MONTGOMERY COUNTY HISTORIC PRESERVATION COMMISSION
STAFF REPORT

Address:	5904 Cedar Parkway, Chevy Chase	Meeting Date:	8/15/2018
Resource:	Outstanding Resource Chevy Chase Historic District	Report Date:	8/8/2018
Applicant:	David O’Neil & Laura Billings (David Jones, Architect)	Public Notice:	8/1/2018
Review:	HAWP	Tax Credit:	Partial
Case Number:	35/13-18Z	Staff:	Dan Bruechert
Proposal:	Garage demolition, non-historic addition removal, new construction, hardscape, and landscape alterations.

STAFF RECOMMENDATION

Staff recommends that the HPC **approve with five conditions** the HAWP application.

TREE REMOVAL PLAN

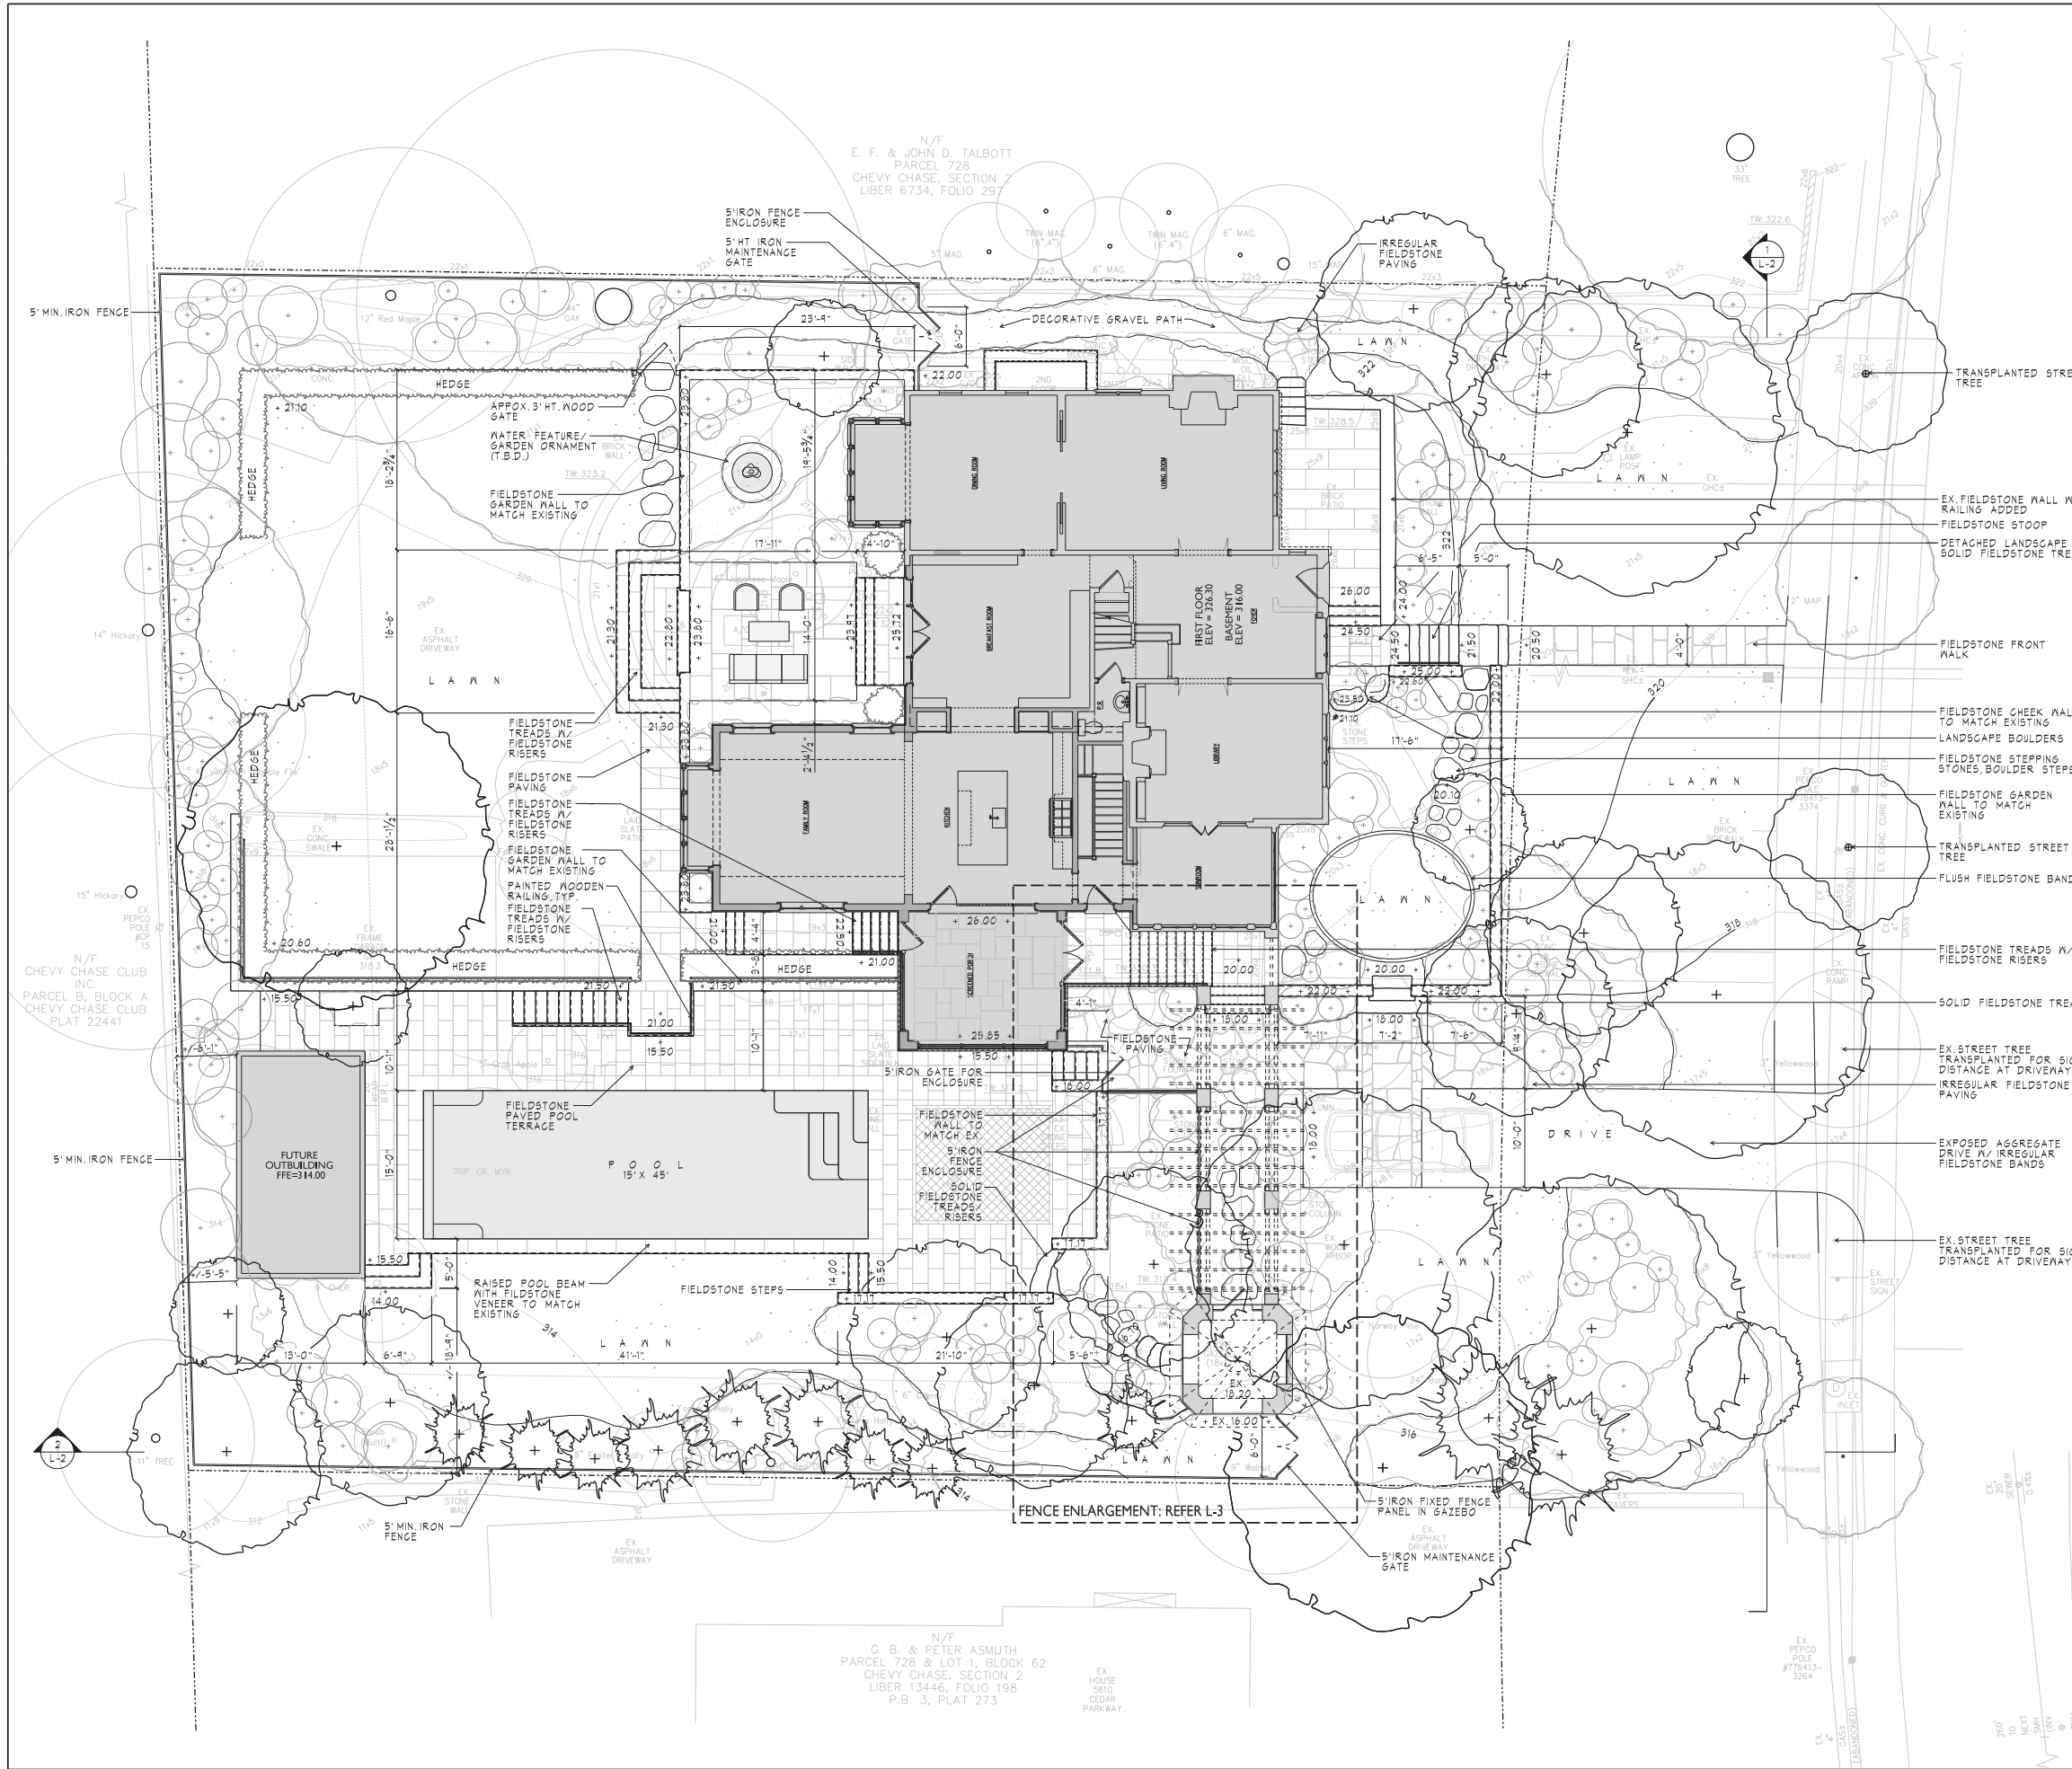
In order to accommodate some of the landscape and hardscape changes proposed, the applicant proposes to remove a total of twenty (20) trees. Fourteen (14) of the trees are larger than 6" (six inches) d.b.h. and subject to HPC review. In front of the house near the proposed driveway and lay-by there are:

- 20" d.b.h Norway Spruce;
- 22" d.b.h. Norway Spruce;
- 24" d.b.h Balsam fir; and a
- 9" d.b.h. Black Walnut

The two Norway Spruce trees and the Balsam fir are in poor health and leaning. The removal of these four trees will have the largest impact on the character of the house.

With the exception of the two large pine trees in the front of the yard, the trees proposed for removal are all relatively young and don't add to the mature tree canopy found throughout the district. To comply with the Chevy Chase Village Urban Forest Ordinance, the applicant will be required to plant a new tree for each one removed. The landscape site plan submitted with the application is only a concept drawing and has not identified the placement and species to be planted on the site. Staff recommends the HPC condition approval of the tree removal on the applicants' submission to Staff of a letter from Chevy Chase Village indicating that the applicant has satisfied the requirements of the Urban Forest Ordinance.

3. Details for the species and placement for the replacement trees must be submitted for review and approval with a letter from Chevy Chase Village stating the that applicant has satisfied the requirements of the Urban Forest Ordinance.

ILLUSTRATIVE ELEVATIONS

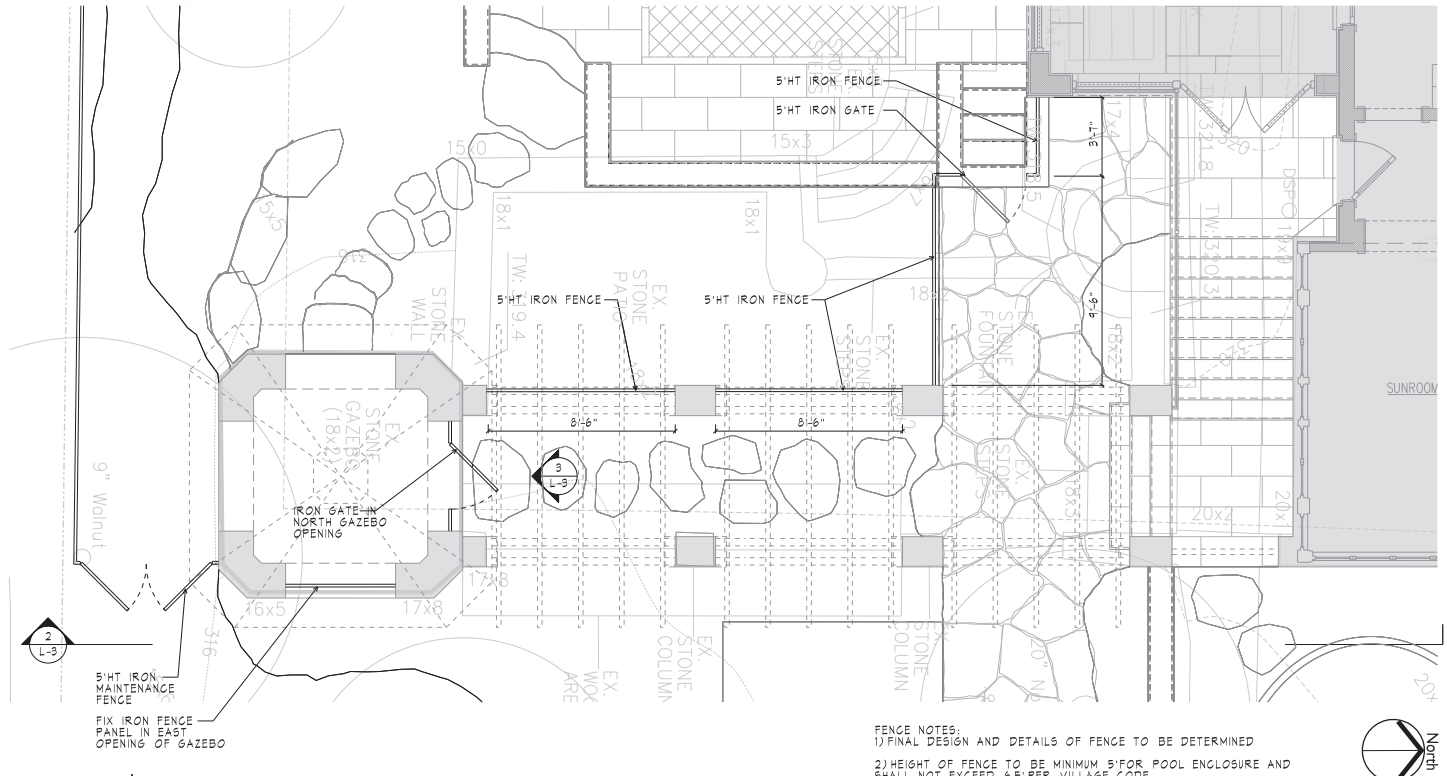
Staff finds that the modification of the front porch does not meet the *Guidelines* requirements given the level of scrutiny (moderate) that is required. Moderate scrutiny evaluates the materials, size, and massing of the proposal with additional considerations for preserving the integrity of the resource. This proposed change also appears to contravene 24A-8(b)(1) by substantially altering a significant exterior feature of this historic resource. As currently designed, the proposed modification of the front porch would result in the loss of significant historic fabric and

alter the appearance and character of the house. Staff recommends the HPC condition approval of this HAWP on retaining the porch in its existing, historic configuration. Staff recognizes that this condition will require an alteration to the proposed front walk and retaining wall. Staff finds the fieldstone pavers to be an appropriate material and recommends that the HPC either require the revised front walkway and retaining wall to be presented to the HPC for review and approval as a Staff item; or to delegate the review and final approval of alterations of the front walk and retaining wall to Staff.

2. The front porch needs to remain in its historic configuration. Revisions to the design of the front walk and retaining wall must be submitted as a Staff Item for review and approval by the HPC.

FENCE ENLARGEMENT

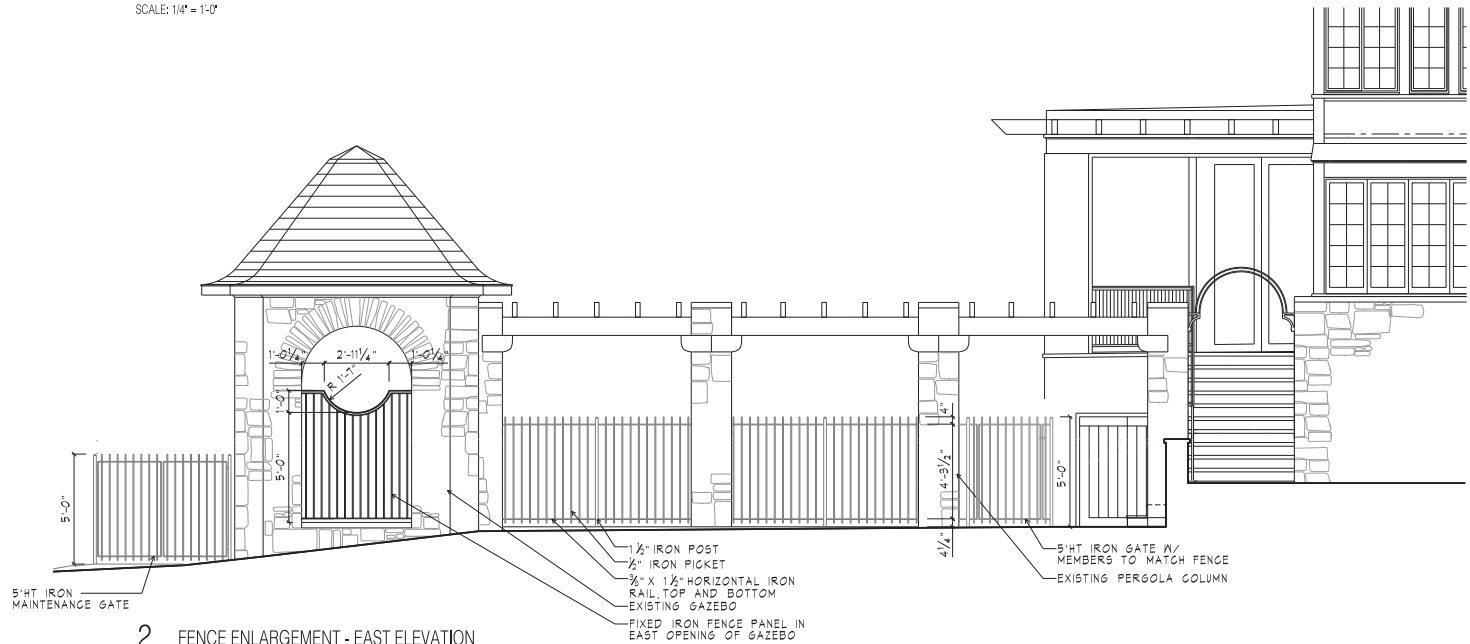
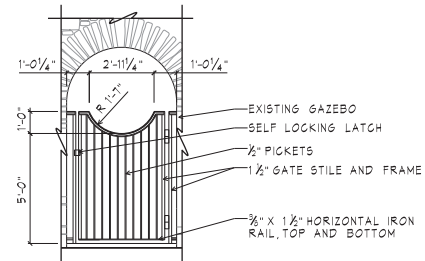
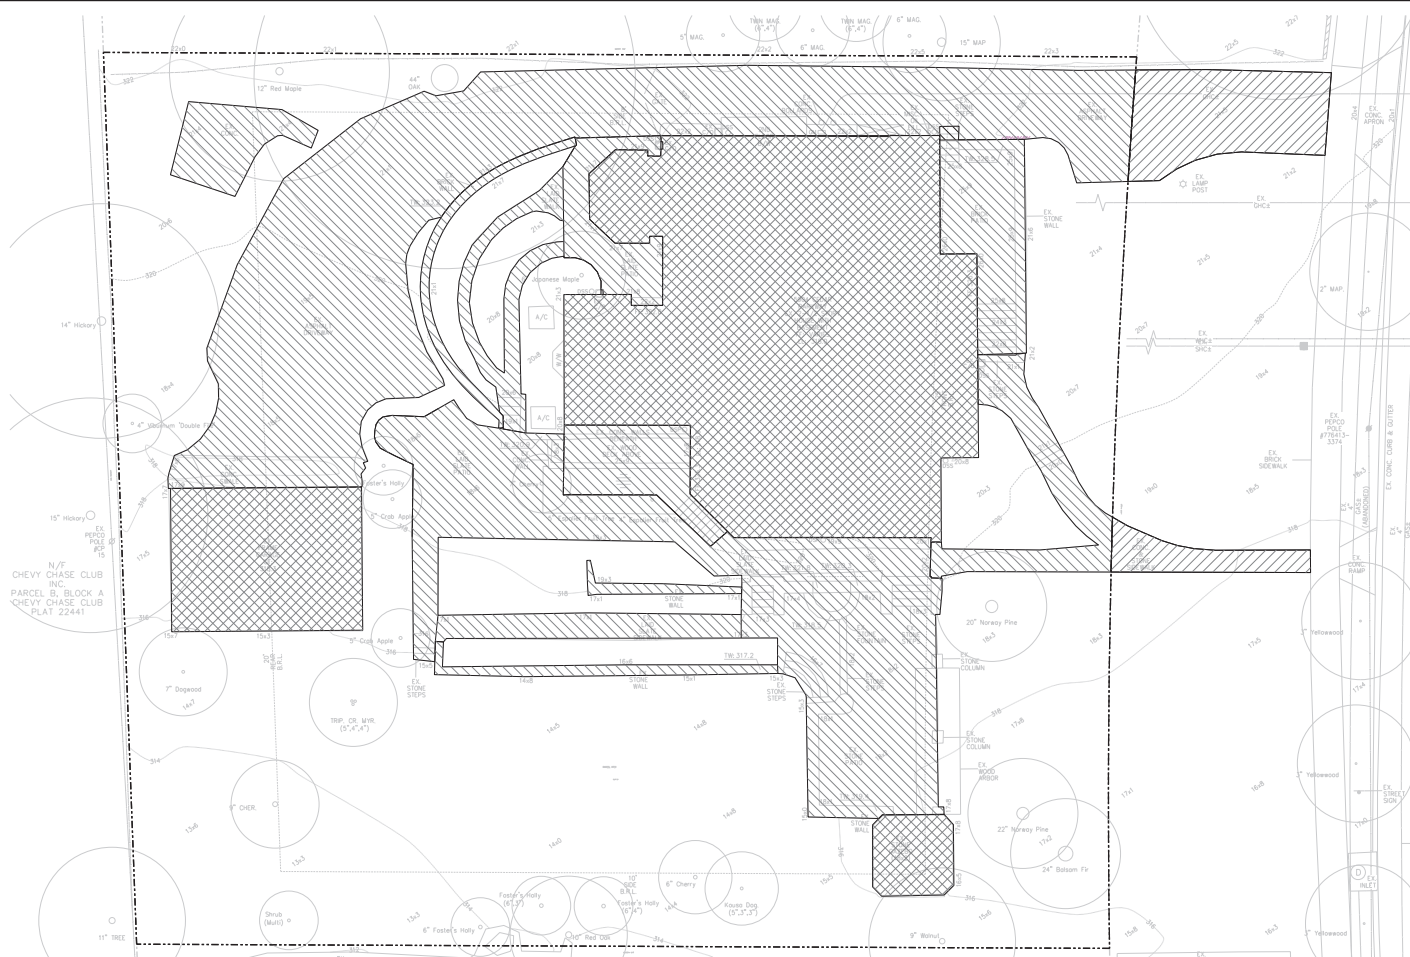
Staff has two recommendations to make the fence better comply with the character of the house and surrounding landscape. First, the fixed iron panel proposed for the east opening of the gazebo/folly should be relocated to the west opening so that the more open appearance of this significant built feature is preserved. Second, the gate to the left (south) of the gazebo/folly should be set an additional 10’ (ten feet) to the west, so that the rear yard is fully enclosed while allowing the gazebo/folly to be fully visible. Review of this element is undertaken with moderate scrutiny. Staff recommends that permit drawings reflect this condition prior to stamping.

1. Placement of the fixed iron fence panel to be installed in the gazebo needs to be moved to the west opening. Additionally, the fence and gate to the left of the gazebo may not project beyond the rear wall plane of the gazebo. Drawings showing this condition has been met need to be submitted to Staff for review and stamping. Drawings must include details (section, etc.) demonstrating how the fence is being set within the folly and affixed to is. The addition of the fence must not contravene the Secretary of the Interior's Standards 9 and 10.
